II. DISCUSSION

The above proposed Technical Specifications changes are requested in order to satisfy NUREG-0472 and staff guidance in the development of Radiological Effluent Technical Specifications.

Palisades Plant - Docket 50-255

TECHNICAL SPECIFICATION CHANGE REQUEST

PALISADES NUCLEAR PLANT  
SITE BOUNDARY  
TLD STATIONS  
FIGURE 5-1

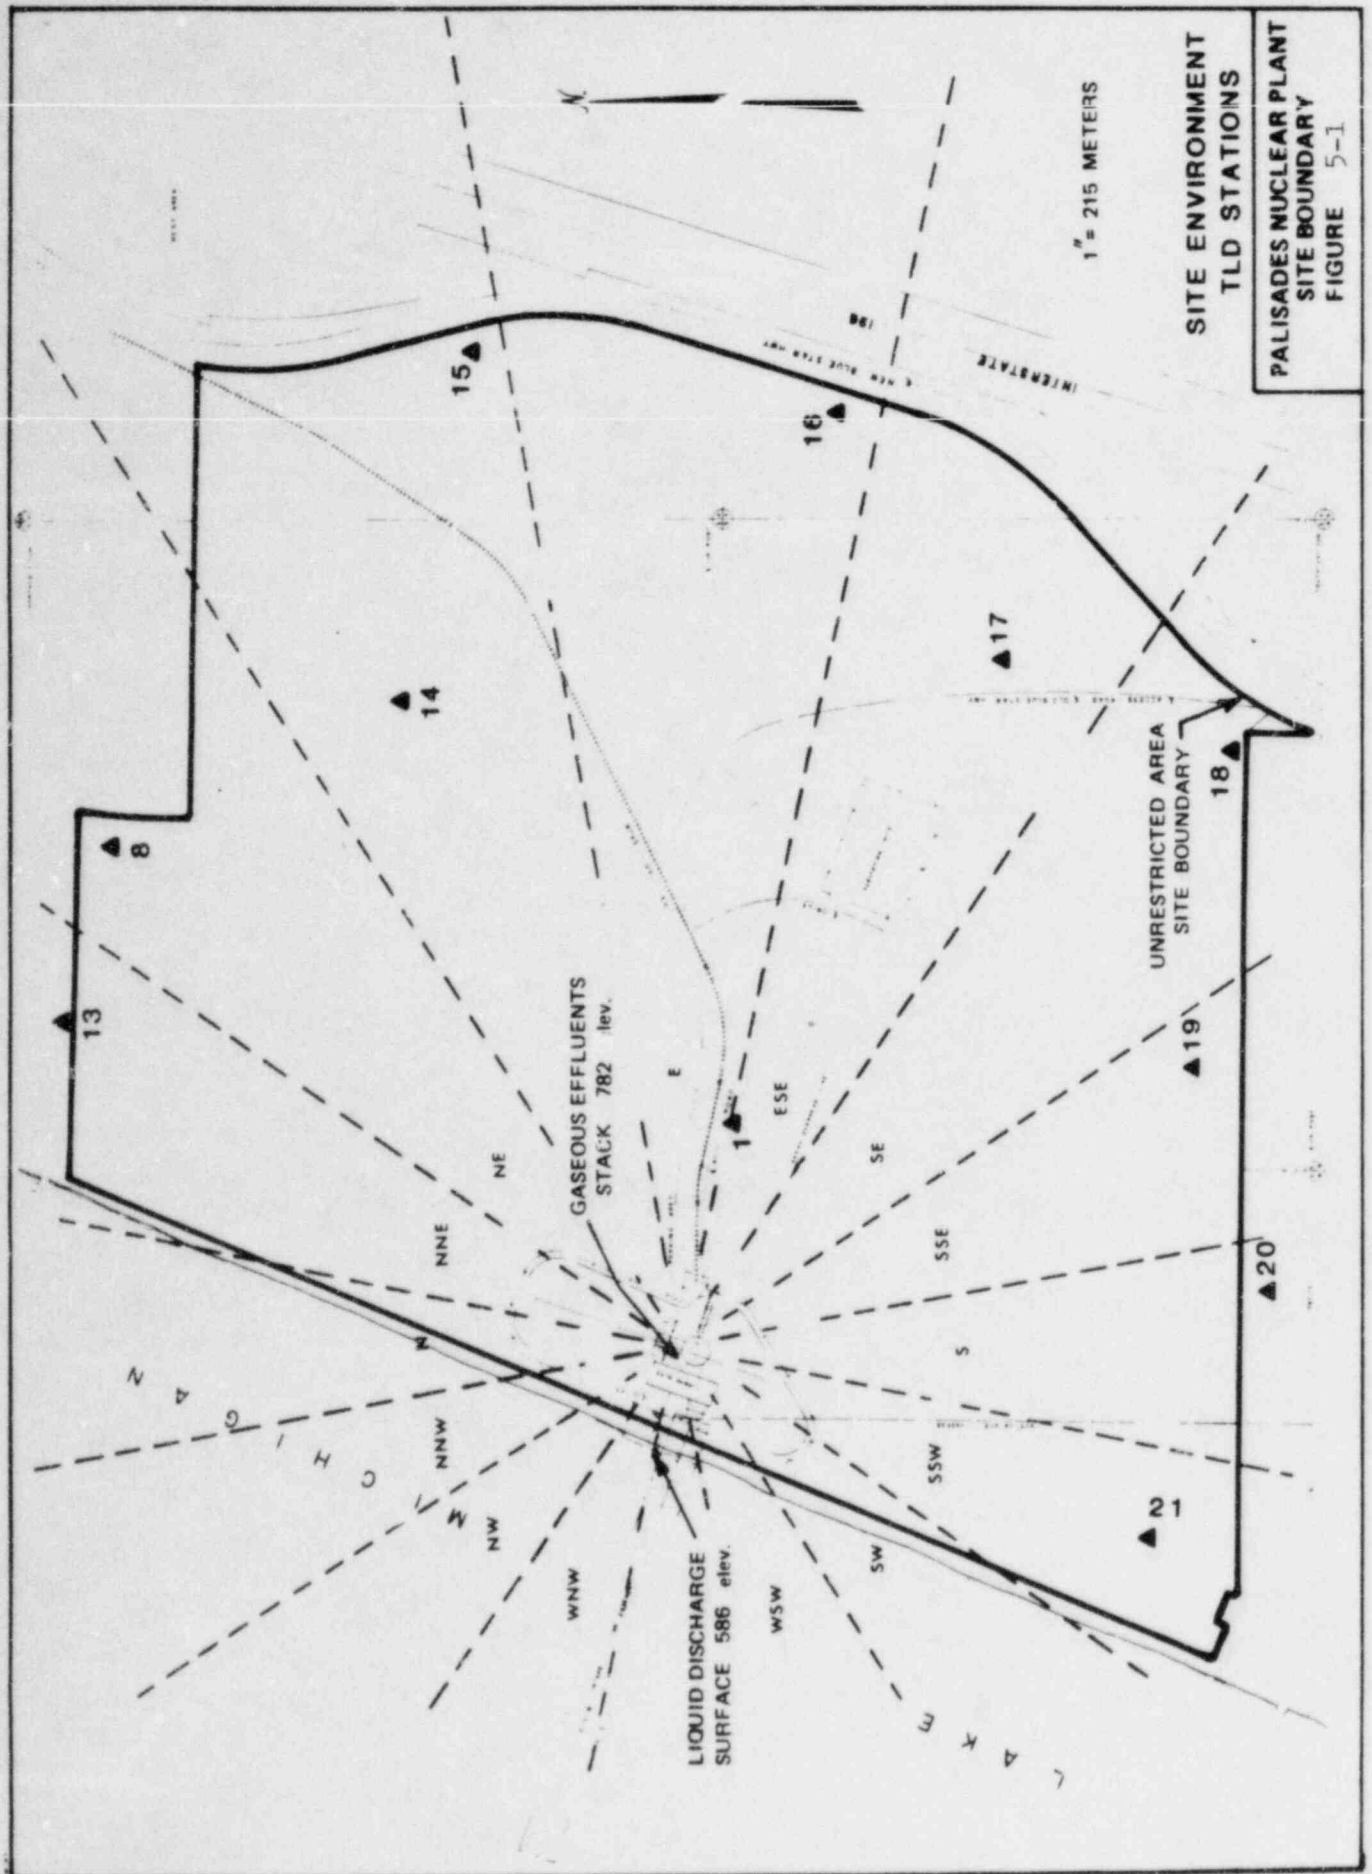
- M. Change the second sentence of Section 5.1 Site to read "Figure 5-1 shows the plan of site."
- N. Add Figure 5-1 "Palisades Nuclear Plant Site Boundary" at the end of Section 5.

- M. and N. A new figure was created for this submittal that clearly shows the site boundary.
- O. and P. Section 6.5.2.8.3 was added and referenced in 6.5.2.8.1.e to delineate NSB responsibilities for ODCM, PCP and radiological environmental monitoring program.
